Access Compliance Report

Public Rights-of-Way

Intersection ID: 2600	Main Street: CAMBELLTON_DR	Cross Street: FAIRMEADOWS_DR	Location:	E
ADA ID: 065041E7D75A	Ramp Type: PerpDiag	Initial Pass/Fail: Fail	Overall Compliance: No	Severity Score: 50

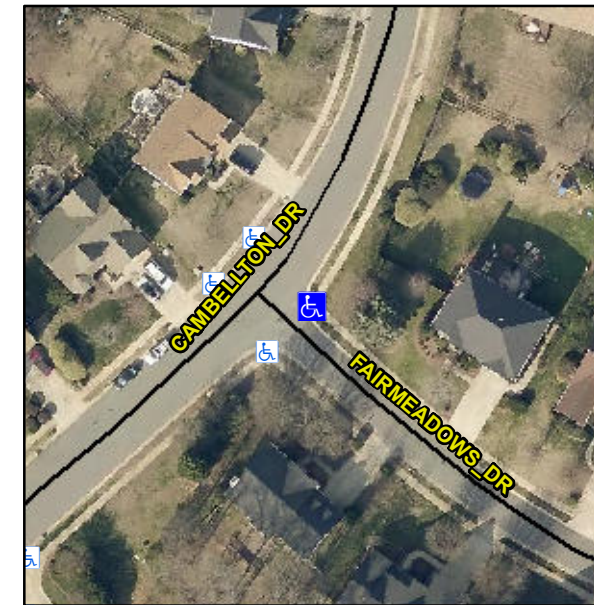
R304.2.2, R304.5.3

Compliance	Description	Data	Compliance	Description	Data
N/A	Ramp Length (in)	47.0	No	Ramp Slope (%)	14.6
Yes	Ramp Width (in)	48.0	No	Ramp XSlope (%)	8.9
N/A	Flare Type LT	N/A	N/A	Flare Type RT	N/A
N/A	Flare Slope LT (%)	N/A	N/A	Flare Slope RT (%)	N/A
N/A	Flare Traversable LT?	N/A	N/A	Flare Traversable RT?	N/A
N/A	Landing Length (in)	N/A	N/A	DWS Provided?	N/A
N/A	Landing Width (in)	N/A	N/A	DWS Contrast?	N/A
N/A	Landing Slope (%)	N/A	N/A	DWS Length (in)	N/A
N/A	Landing X Slope (%)	N/A	N/A	DWS Full Width?	N/A
N/A	Landing Curb? (Y/N)	N/A	N/A	DWS Offset (in)	N/A
N/A	Shared Landing?	N/A			
N/A	Gutter Ponding?	N/A	N/A	Gutter Slope (%)	N/A
N/A	Gutter Lip Ht (in)	N/A	N/A	Gutter X Slope (%)	N/A
N/A	Painted X Walk1?	No	N/A	Painted X Walk2?	No
	X Walk 1 Direction	To NW		X Walk 2 Direction	To SW
N/A	X Walk 1 Width (in)	N/A	N/A	X Walk 2 Width (in)	N/A
	X Walk 1 Slope (%)	4.9		X Walk 2 Slope (%)	3.6
	X Walk 1 X Slope (%)	6.8		X Walk 2 X Slope (%)	6.5

Remove & Replace Curb Ramp With Two New Directional Ramps or Equivalent.
